**CITY OF CAMARILLO
WATER DIVISION**

**AMENDMENTS TO THE
STANDARD SPECIFICATIONS
REVISED JULY 2005**

W-35

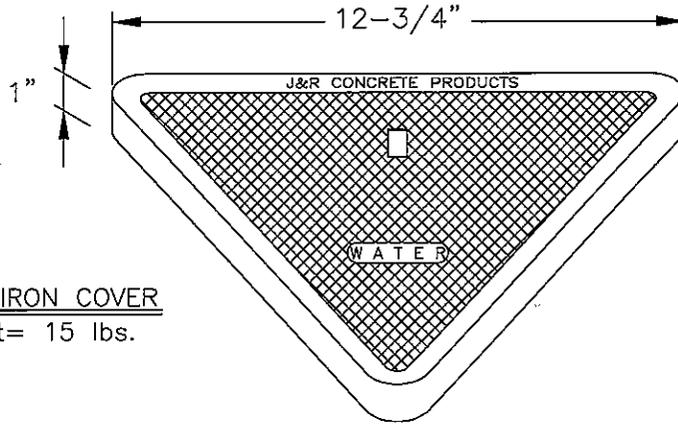
Insert the following:

NOTE:

SEE WATER DIVISION STAFF FOR INSTALLATION REQUIREMENTS.

**No. V4-T
VALVE BOX SERIES
FOR H-10 LOADING**

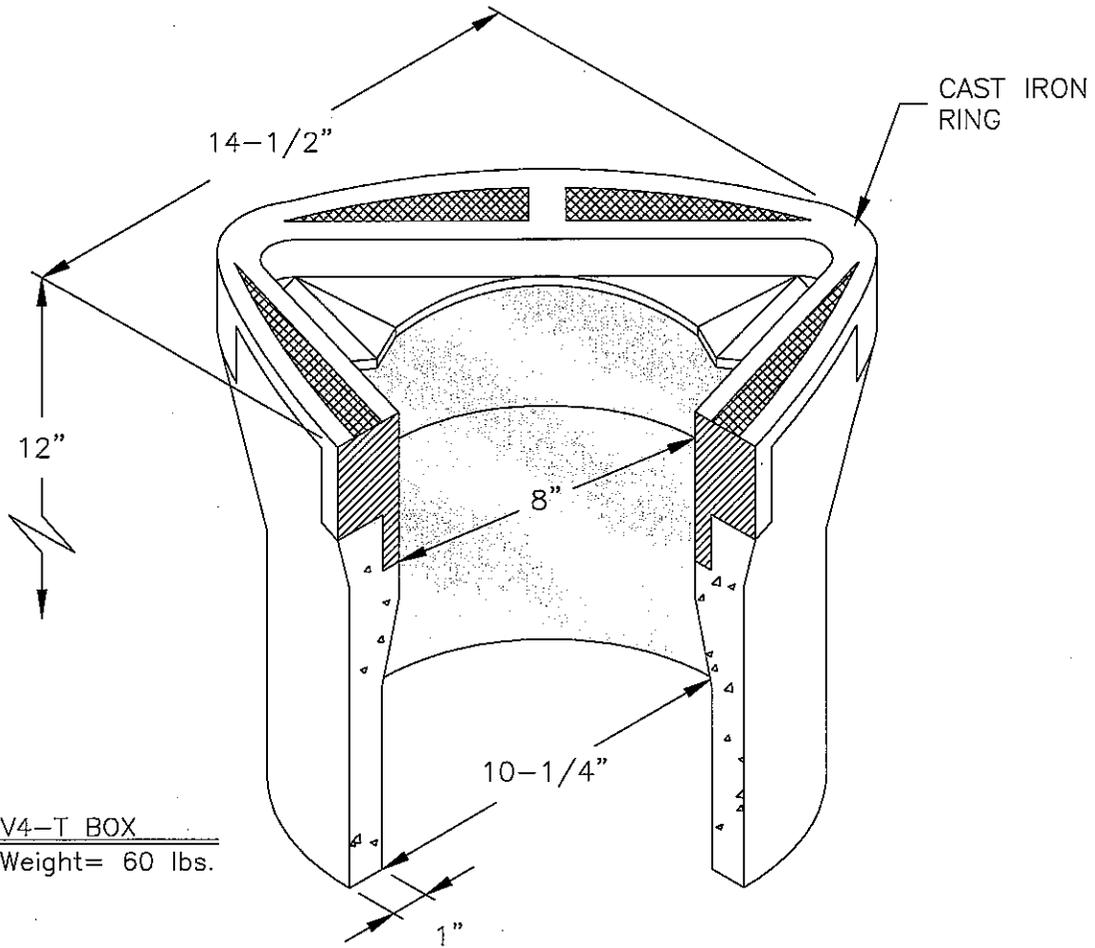
Change "CHRISTY" to "J&R CONCRETE PRODUCTS No. V4-T" (SEE ATTACHMENT #1)
